SECY-79-606

Subject: ISSUANCE OF STAFF CRITERIA FOR THE MARK I CONTAINMENT
LONG TERM PROGRAM

NRC ACCEPTANCE CRITERIA
FOR THE
MARK I CONTAINMENT
LONG TERM PROGRAM

Figure 2.6-1 Schematic Diagram Illustrating the Methodology for Main Vent Impact and Drag

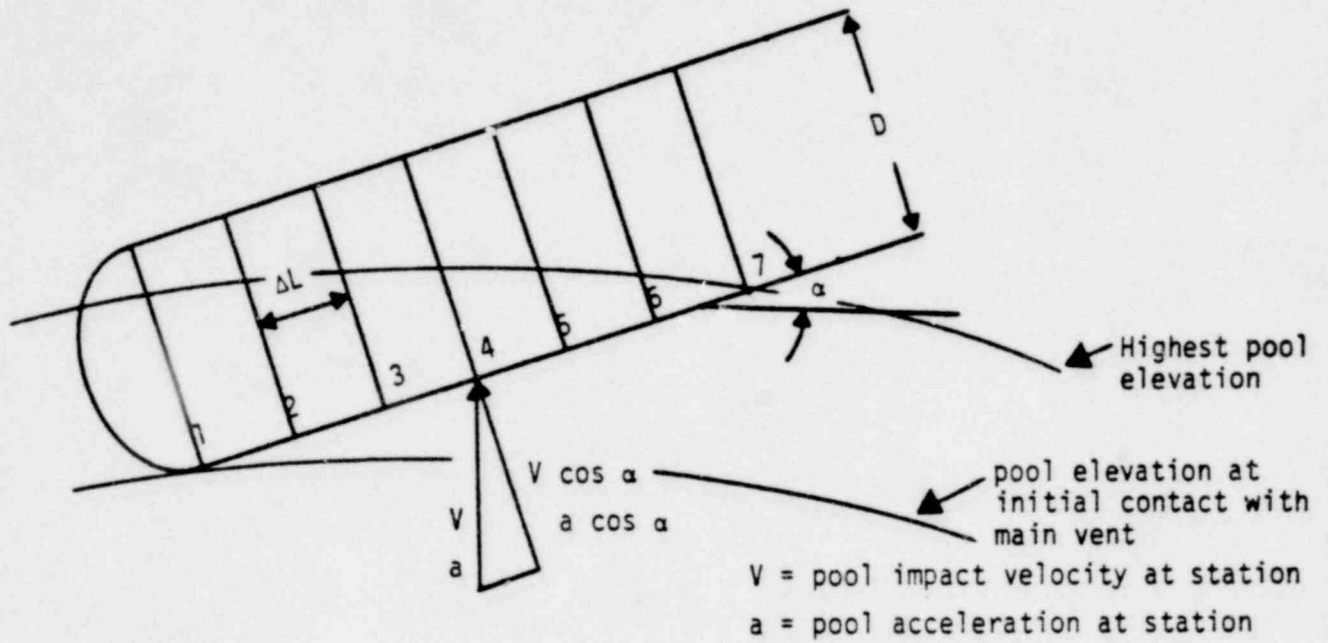
1. Subdivide the submerged portion of the main vent pipe into six equally wide segments (see Figure 2.6-1). If this subdivision results in $\Delta L < 0.3D$ fewer segments may be used such that $\Delta L \sim 0.3D$.
2. Determine the velocity and acceleration histories at Points 1 through 7 in Figure 2.6-1 from the QSTF data and appropriate corrections for longitudinal variations along the torus (at Point 7, only the initial impact velocity is required).
3. Using the velocity components normal to the vent pipe, calculate the impact and "steady" drag pressure using the method in Section 2.7.1 (Cylindrical Structures). At Point 7, only impact force is to be considered.

Using the acceleration components normal to the vent pipe, calculate the acceleration drag pressure using the equation

$$P_a = \frac{\rho}{2g_c} \left(\frac{\pi D}{144} \right) \dot{V} + \frac{F_{\text{static buoyancy}}}{DL}$$

Where P_a is the acceleration pressure averaged over the projected area (psi), ρ is the density of water (lbm/ft³), D is the diameter in feet, \dot{V} the cross flow acceleration (ft/sec²) and g_c is the acceleration due to gravity (ft/sec²).

4. Sum the pressures due to impact, viscous drag and acceleration drag and multiply by D to obtain force per unit length at Stations 1 through 7.
5. To obtain a smooth loading history for the main vent as a whole, the linear interpolation method suggested for the vent header deflector in Section 3.5 of NEDO-24612 may be used.

Figure 2.7-1 Pulse Shape for Water Impact on Cylindrical Targets

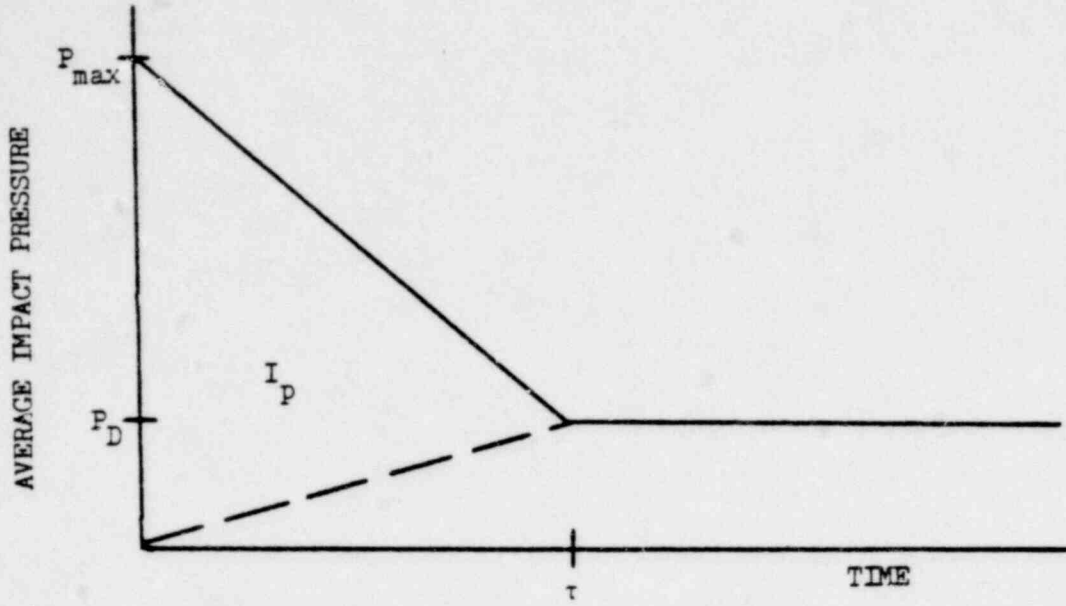
For cylindrical structures, the pressure transient which occurs upon water impact and subsequent drag is depicted in Figure 2.7-1. The parameters in Figure 2.7-1 shall be defined as follows:

1. The maximum pressure of impact P_{max} will be determined by

$$P_{\text{max}} = 7.0 \times \frac{1}{2} \left(\frac{\rho V^2}{144 g_c} \right)$$

where P_{max} is the maximum pressure averaged over the projected area (psi), ρ is the density of water (lbm/ft³), V is the impact velocity (ft/sec) and g_c is the acceleration due to gravity (ft/sec²).

Figure 2.7-2 Drag Coefficient for Cylinders Following Impact

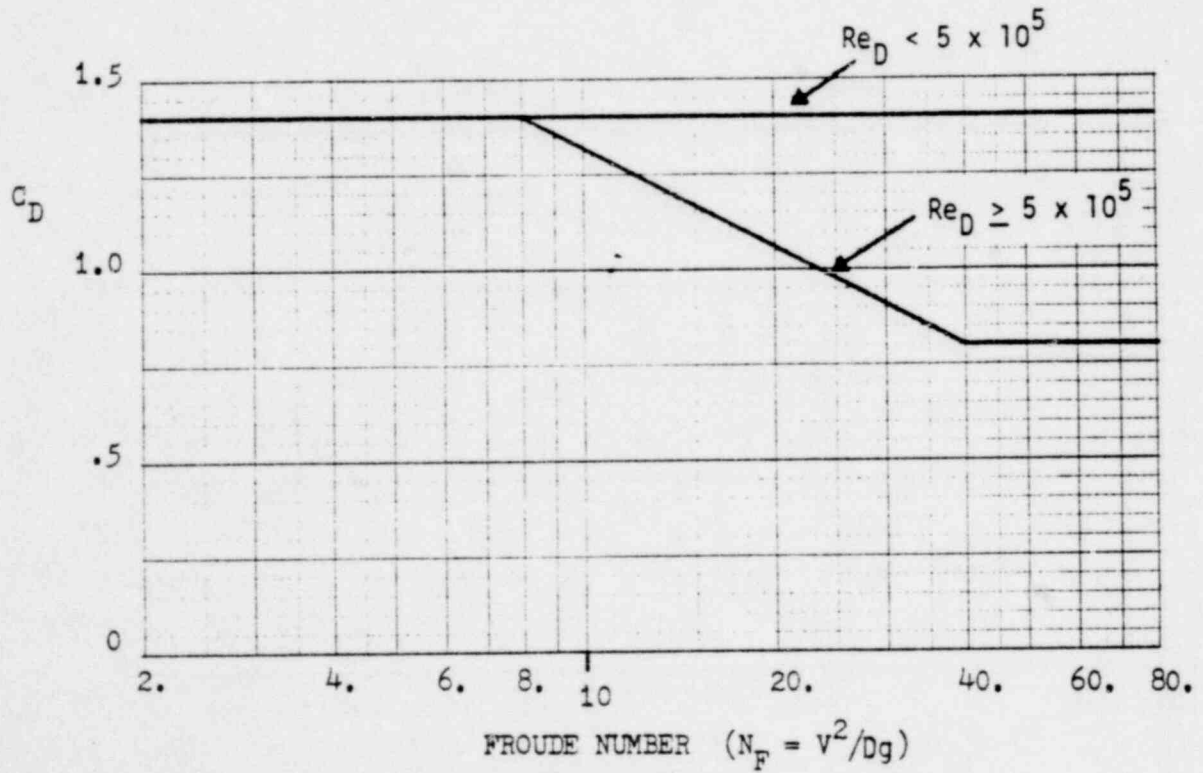
where P_D is the average drag pressure acting on the projected area of the target (psi), C_D is the drag coefficient as defined by Figure 2.7-2, and ρ is the density of water (lbm/ft³).

Figure 2.7-3 Pulse Shape for Water Impact on Flat Targets

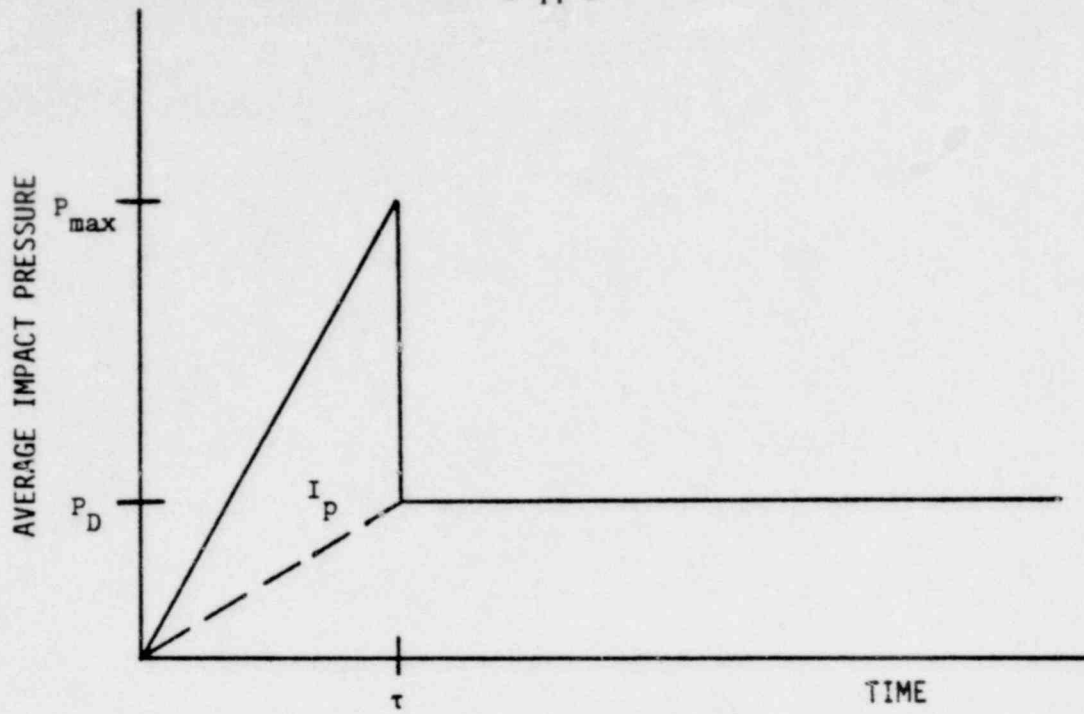
For flat-surface structures, the pressure transient which occurs upon water impact and subsequent drag is depicted in Figure 2.7-3. The parameters in Figure 2.7-3 shall be defined as follows:

1. The pulse duration (τ) is specified as a function of the impact velocity:

$$\tau = 0.0016W \quad \text{for } V \leq 7 \text{ ft/sec}$$

$$\tau = \frac{0.011 W}{V} \quad \text{for } V > 7 \text{ ft/sec}$$

where W is the width of the flat structure (feet) and V is the impact velocity (ft/sec).

Figure 2.7-4 Pressure Drop Due to Flow Across Gratings

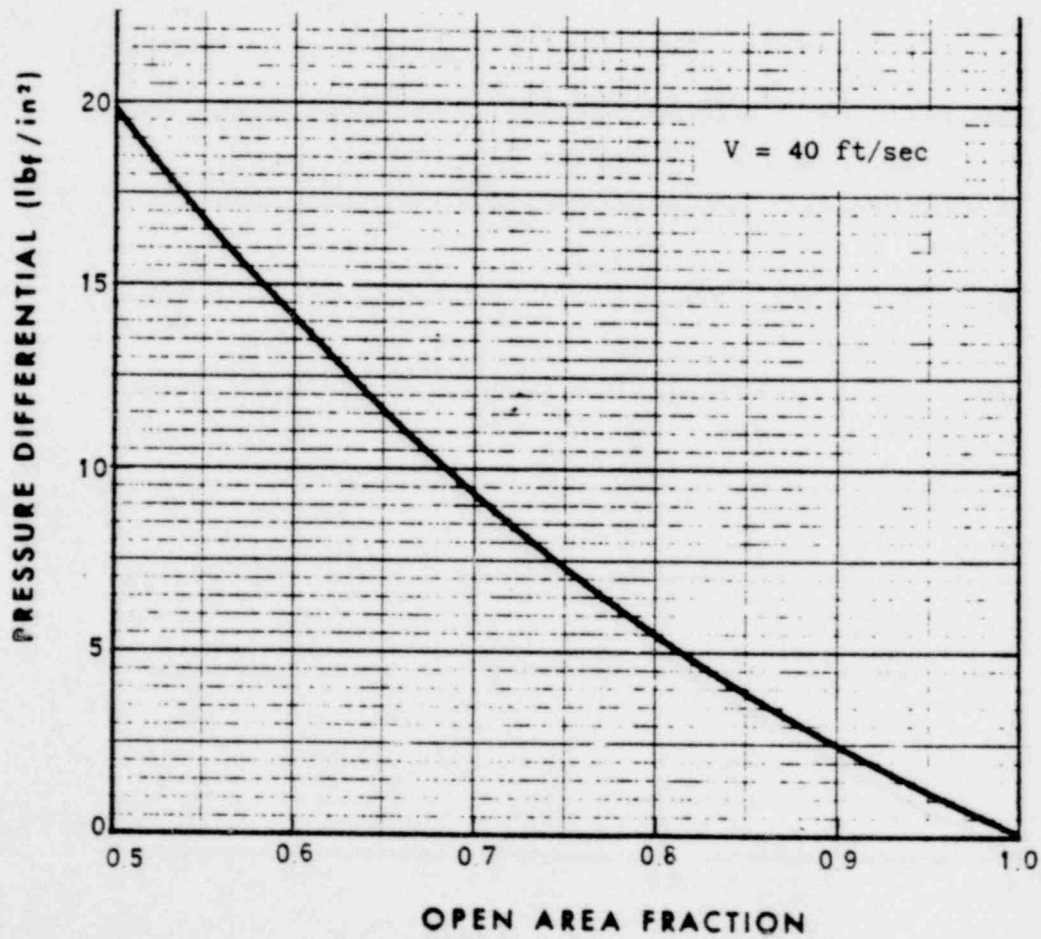
The static drag load on gratings in the pool swell zone of the wetwell shall be calculated for gratings with open areas greater than or equal to 60% by forming the product of the pressure differential (figure 2.7-4) and the total grating area (not only the area of the metal bars). The pressure differential curve in Figure 2.7-4 is based on a velocity of 40 ft/sec. If the maximum pool velocity in the area where gratings are located differs from 40 ft/sec, the force on the grating will be calculated as follows:

$$F = \Delta P \times A_{grating} \left(\frac{V_{max}}{40} \right)^2$$

Figure 2.7-5 Impulsive Impact Loading Region for Structures with a Natural Frequency Less Than 30 Hz

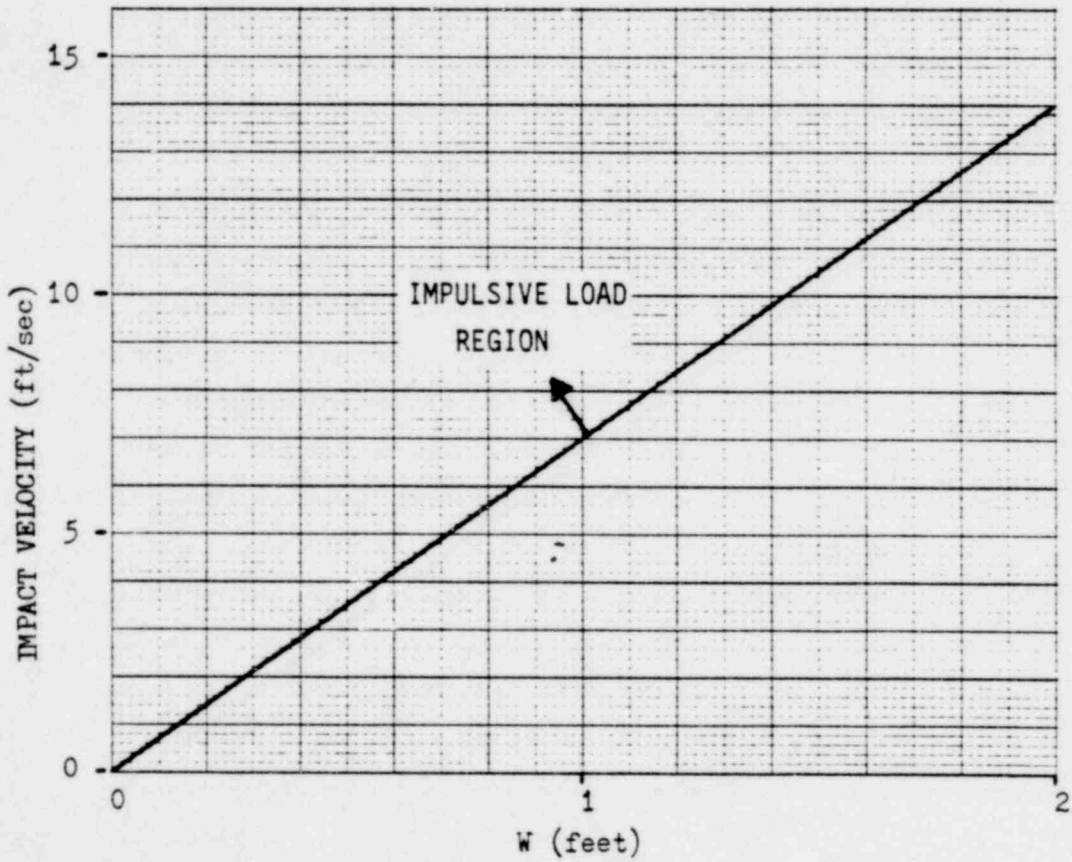
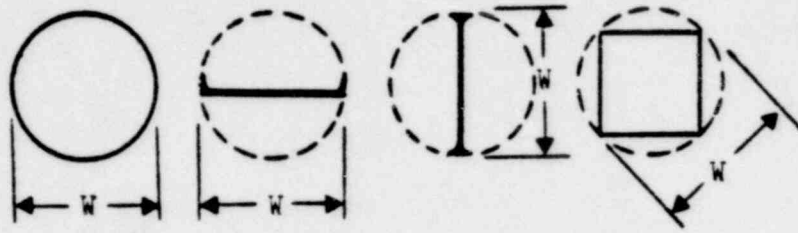
For structures with a natural frequency less than 30 Hz, loading can be treated impulsively (i.e., independent of pulse shape) when the conditions fall into the region above the straight line shown in Figure 2.7-5.

Figure 2.7-6 Effect of Drag Following a Parabolic Impact Pulse

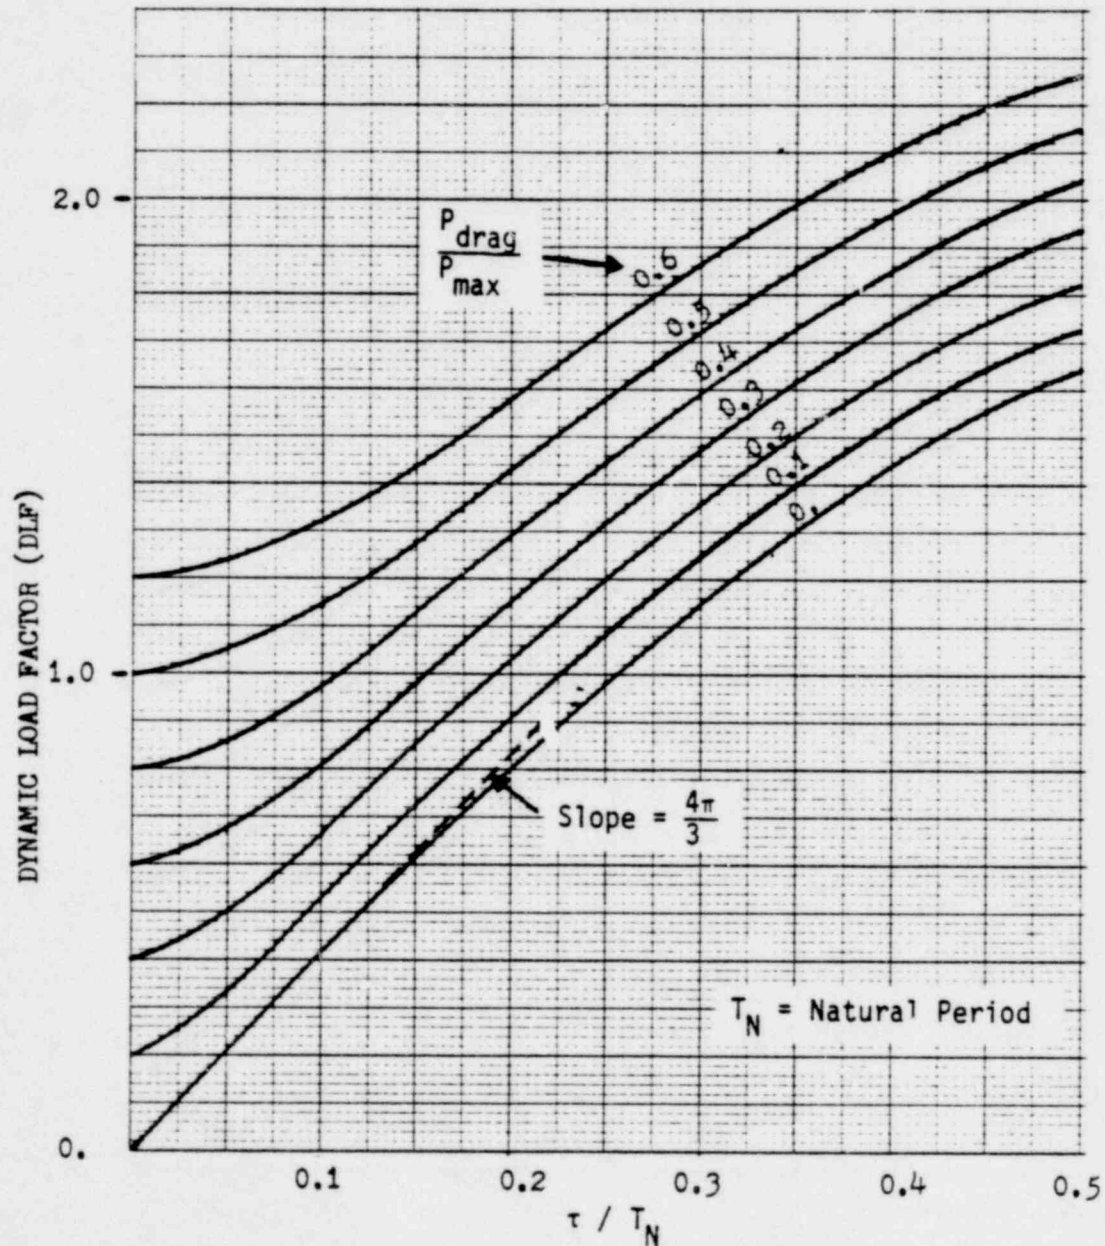
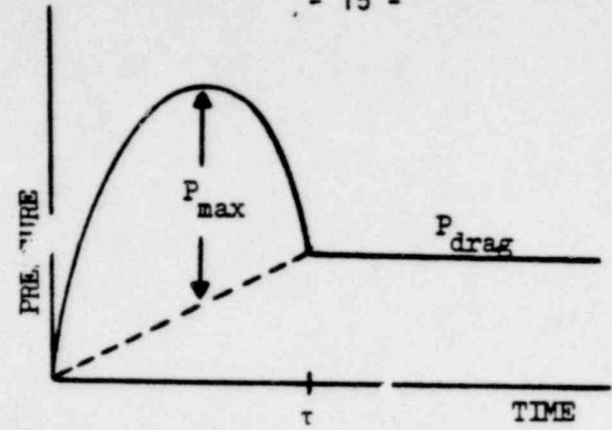
- c. Determine the dynamic load factor (DLF) from Figure 2.7-6, corresponding to the two cases: (1) parabolic pulse without drag and (2) parabolic pulse followed by drag.
- d. Multiply the calculated stress by the factor

$$DLF_{with\ drag}/DLF_{w/o\ drag}$$

Figure 2.8-1 Direction of Load Application for Froth Region I

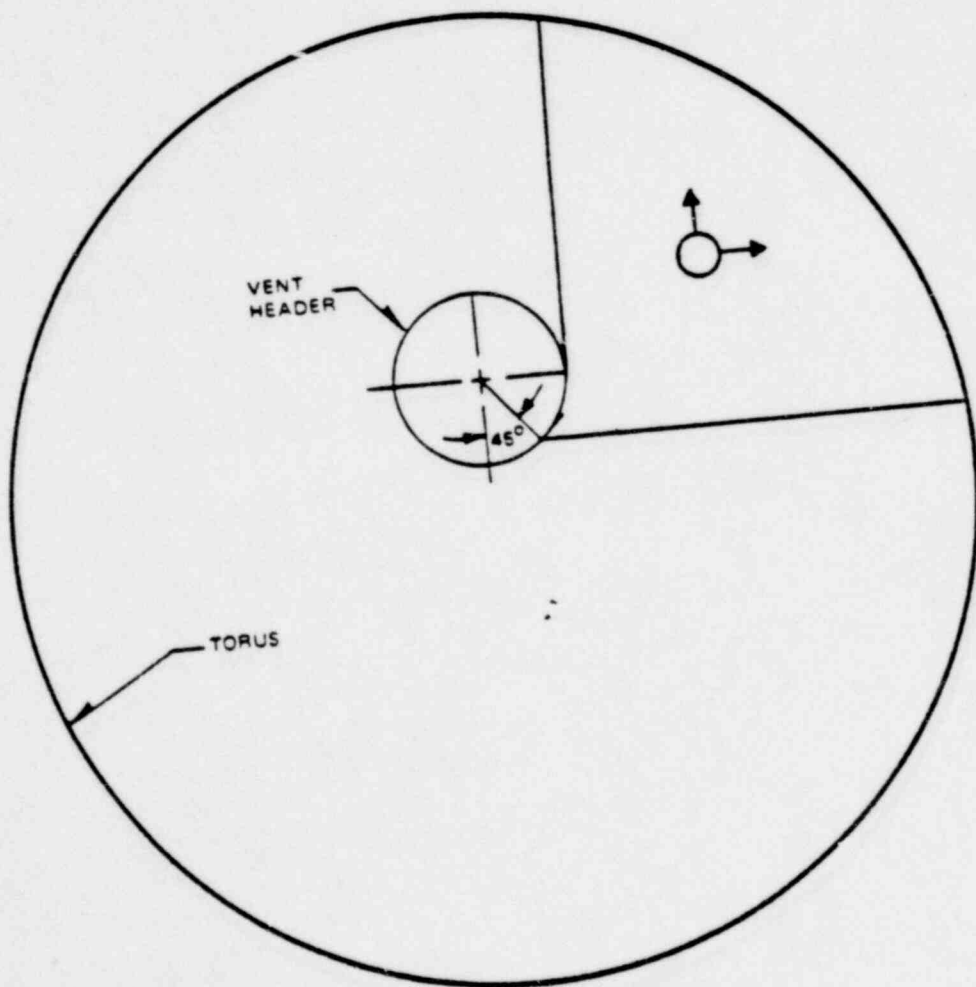
Region I: The froth velocity shall be based on a source velocity equal to 2.5 times the maximum pool surface velocity prior to vent header impact, which is corrected for subsequent deceleration due to gravity starting at the 45° tangent on the bottom of the vent header, as shown in Figure 4.3.5-1 of the LDR. The froth density shall be assumed to be 20% water density for structures or sections of structures with a maximum cross-sectional dimension of less than

or equal to one foot, and a proportionately lower density for structures greater than one foot; i.e., $\rho = (0.2/x) \rho_w$, where x is the dimension in feet. The load shall be applied in the direction most critical to the structure within the 90° sector bounded by the horizontal opposite the vent header to the vertical upward as shown in Figure 2.8.1. The load shall be assumed to be a rectangular pulse with a duration of 80 milliseconds.

Figure 2.10-1 Impact Force Transient for Addition to the Empirical Data for Deflector Types 1 - 3.

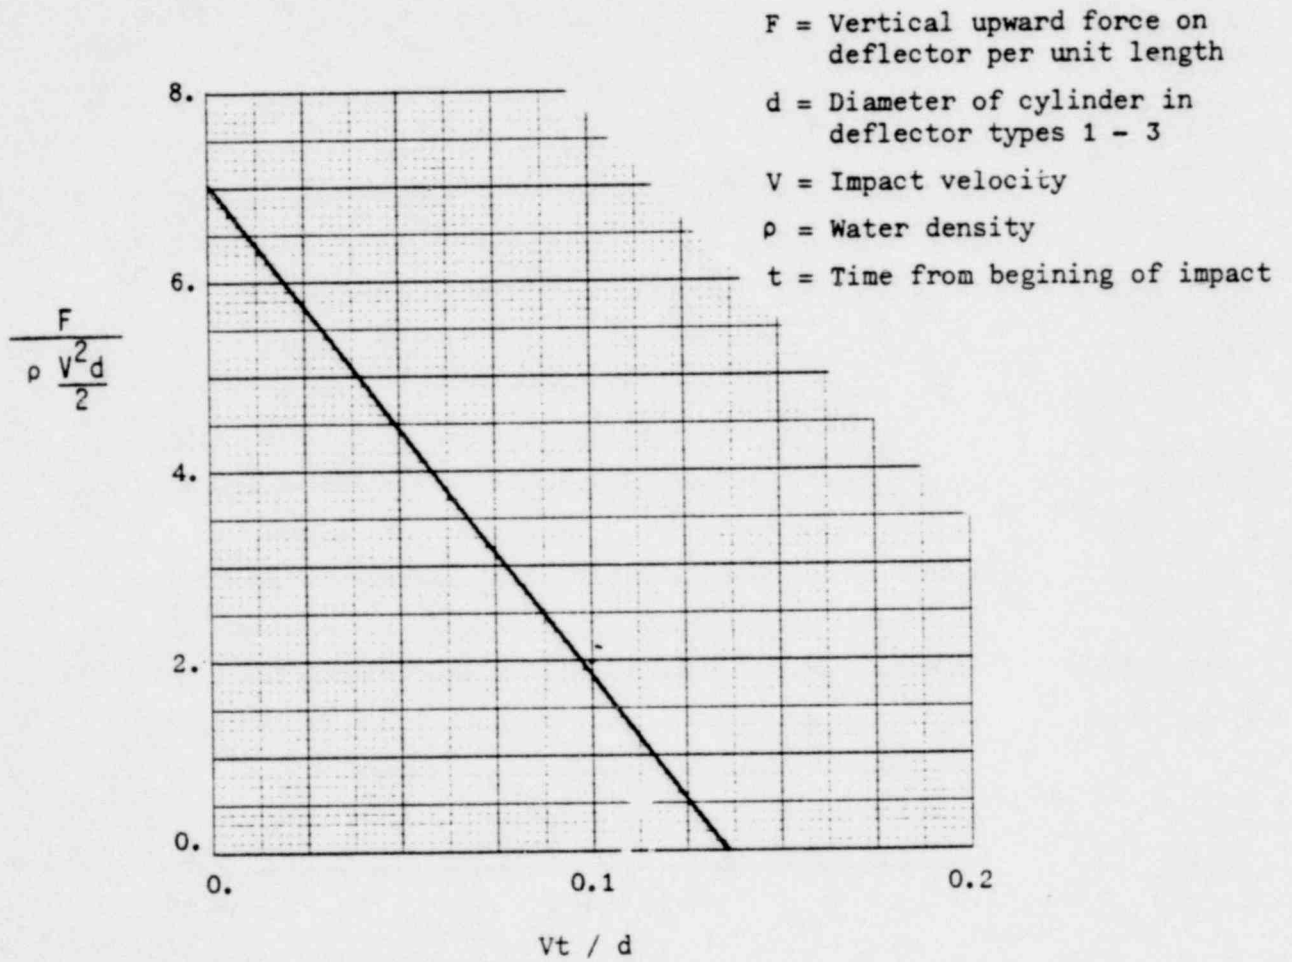
1. If the QSTF deflector load measurement does not have a sufficiently fast response time to resolve the initial impact pressure spike for the deflector types 1 - 3, inclusive, the loading transient shall be adjusted to include the empirical vertical force history of the spike shown in Figure 2.10-1. This impulse need not be applied for the type 4 deflector.
